NORTHERN GOLDFIELDS INTERCONNECT PIPELINE EPA ENVIRONMENTAL REFERRAL

Additional Information

Document No		20199-RP-HSE-0004			
Rev	Date	Status	Originated	Checked	Approved
1.0	30/04/2021	Issued for Use			
			-	S. van Straaten	R. Kallath
			(CDM Smith)	Manager Access and Approvals: West	Project Manager
0.1	03/03/2021	Issued for Review			
			-	S. van Straaten	R. Cherney
			(CDM Smith)	Manager Access and Approvals: West	Project Manager

Figure 7-1: Mapping of Calcrete Groundwater Assemblage PECs

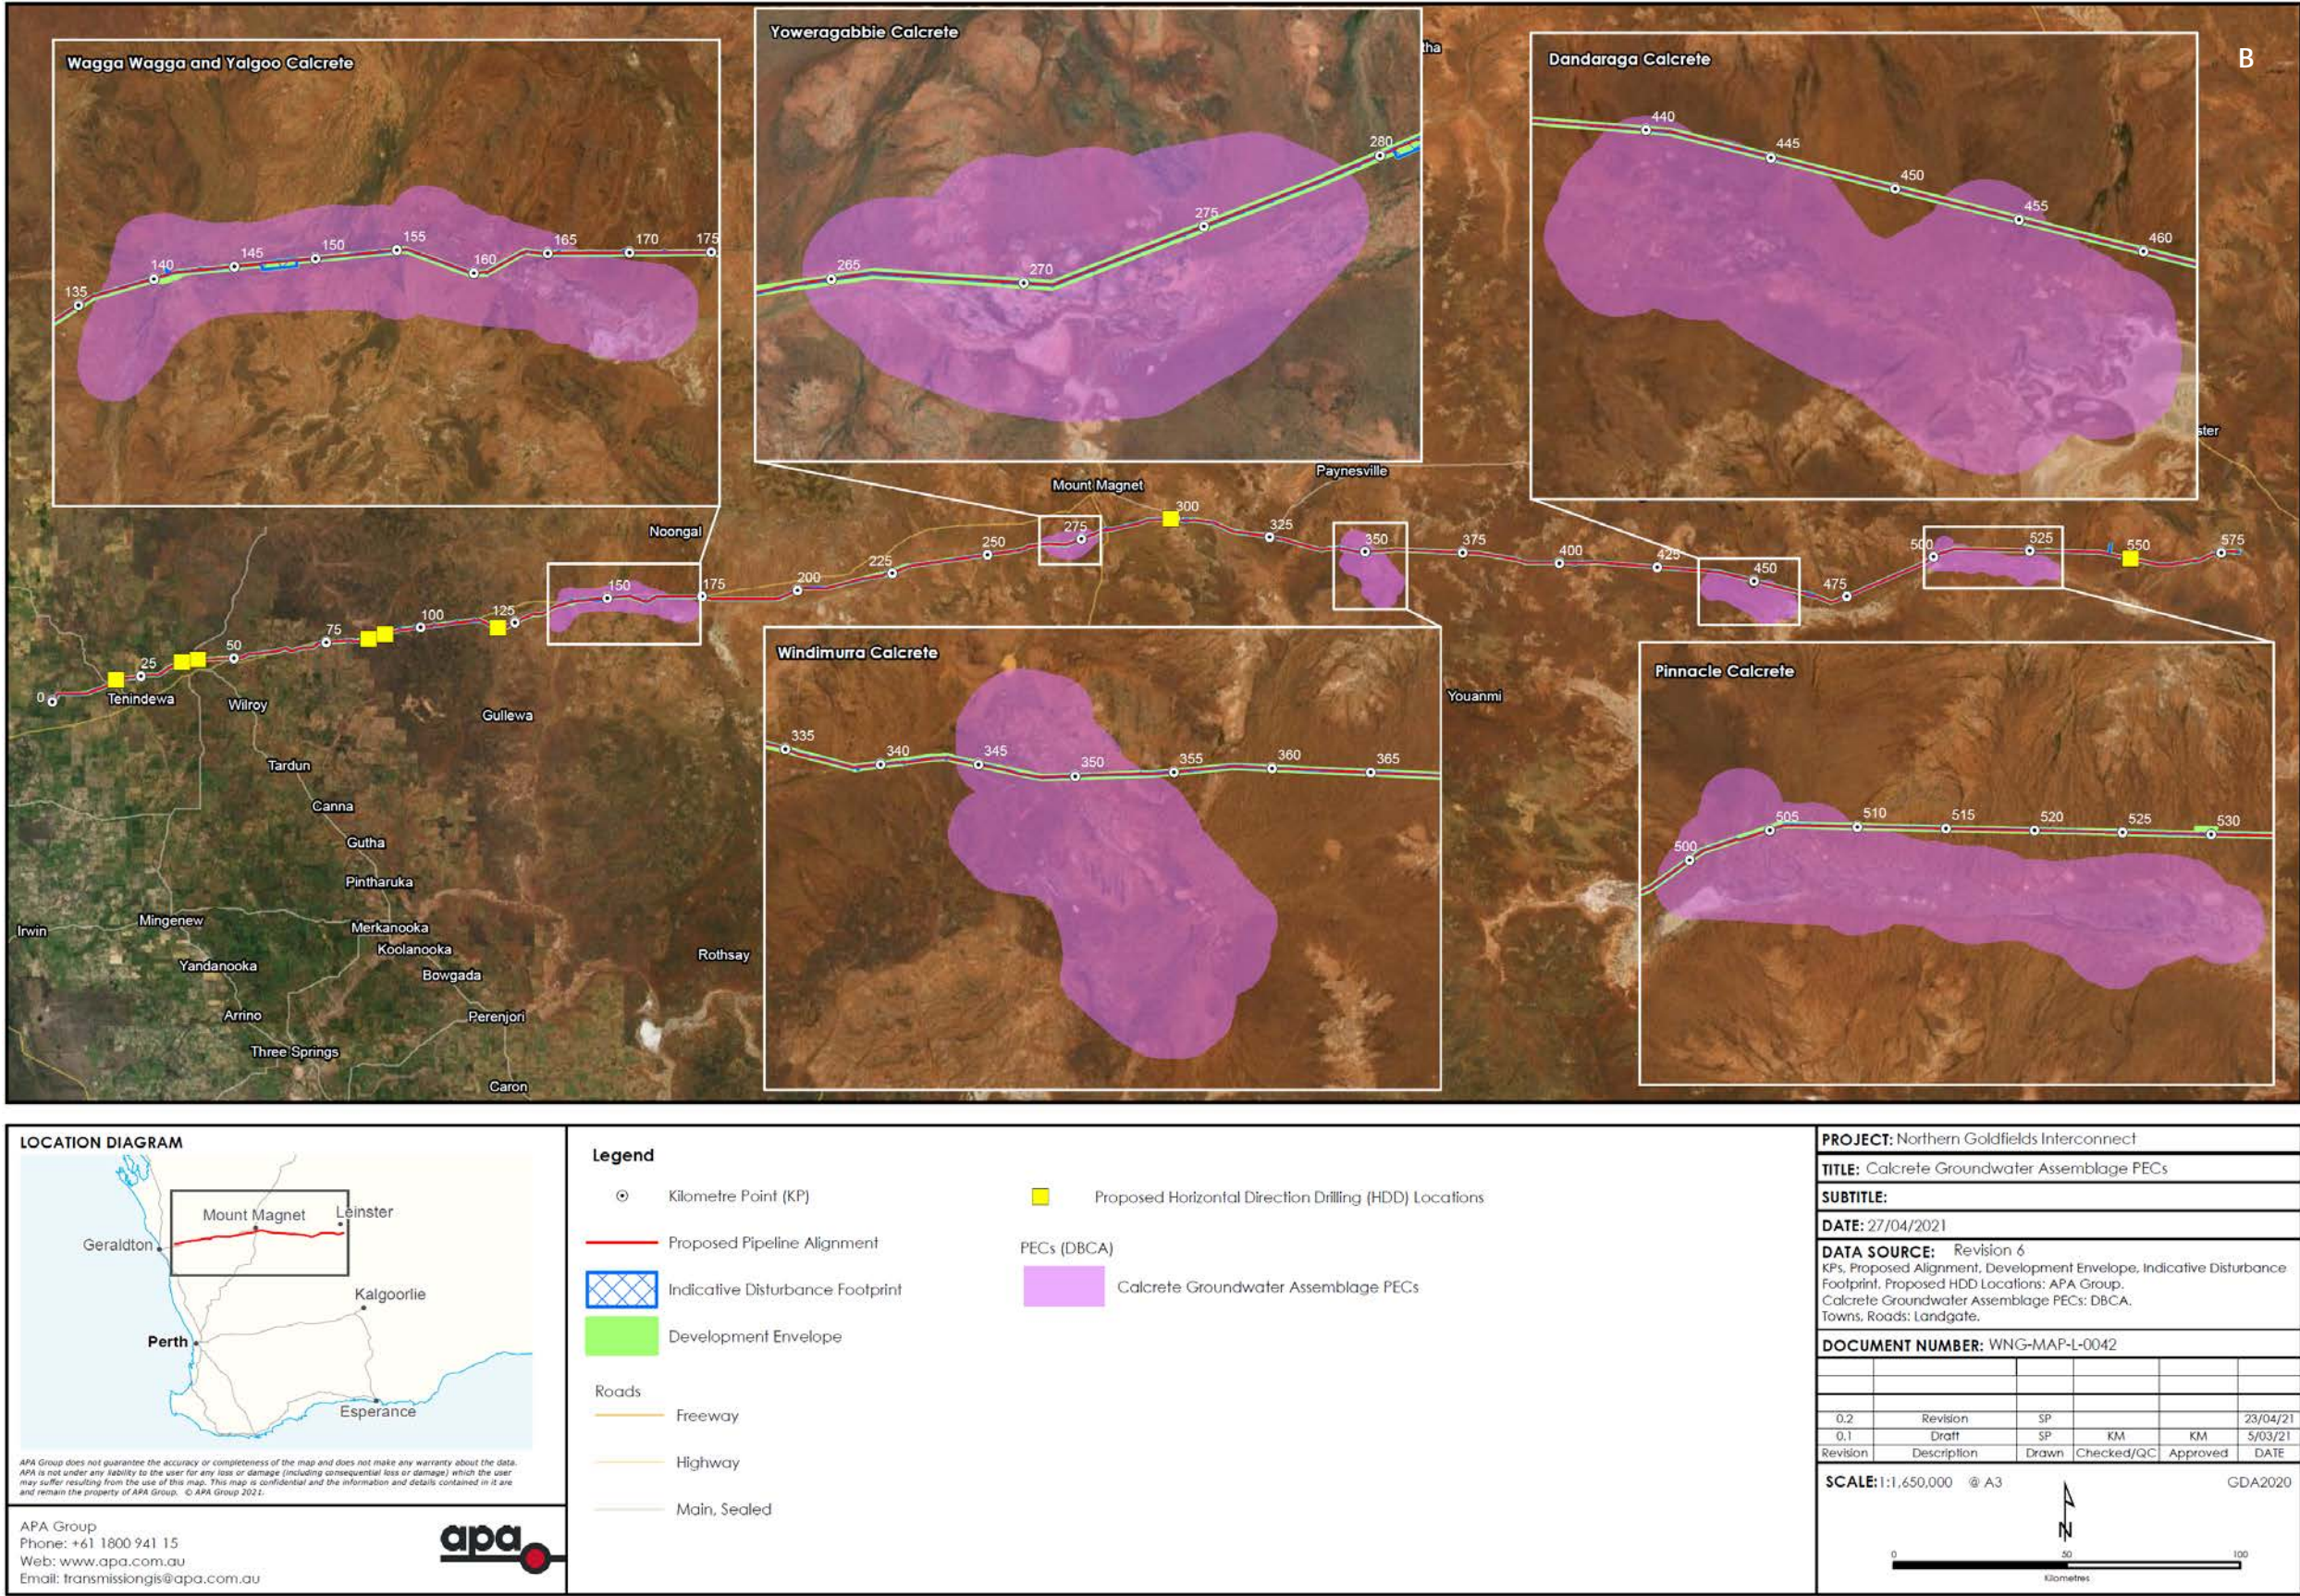
The EPA notes that the proposed pipeline will intersect five calcrete priority ecological communities (PECs), which have the potential to support locally endemic subterranean fauna communities. Please provide information that demonstrates that suitable habitat for subterranean fauna does not occur in the proposed development envelope, as stated in your referral document. Where there is suitable habitat please identify the potential impacts of the implementation of the proposal on the subterranean fauna communities within these PECs and, where relevant and appropriate, the avoidance and mitigation measures for any potential indirect impacts.

The mapped locations of the above PECs, relative to the Proposal linear alignment, are shown in **Figure 7-1**.

Since the time of referral, the project team has progressed the definition of areas of HDD works, which represent the deepest point of excavation relevant to the Proposal. It is confirmed that these areas of HDD works do not occur in or directly adjacent to any of the PECs as shown in **Figure 7-1**.

Additionally, none of the locations where groundwater has been intersected (refer to **Section 7.1.1**) occur within or directly adjacent to any of the PECs.
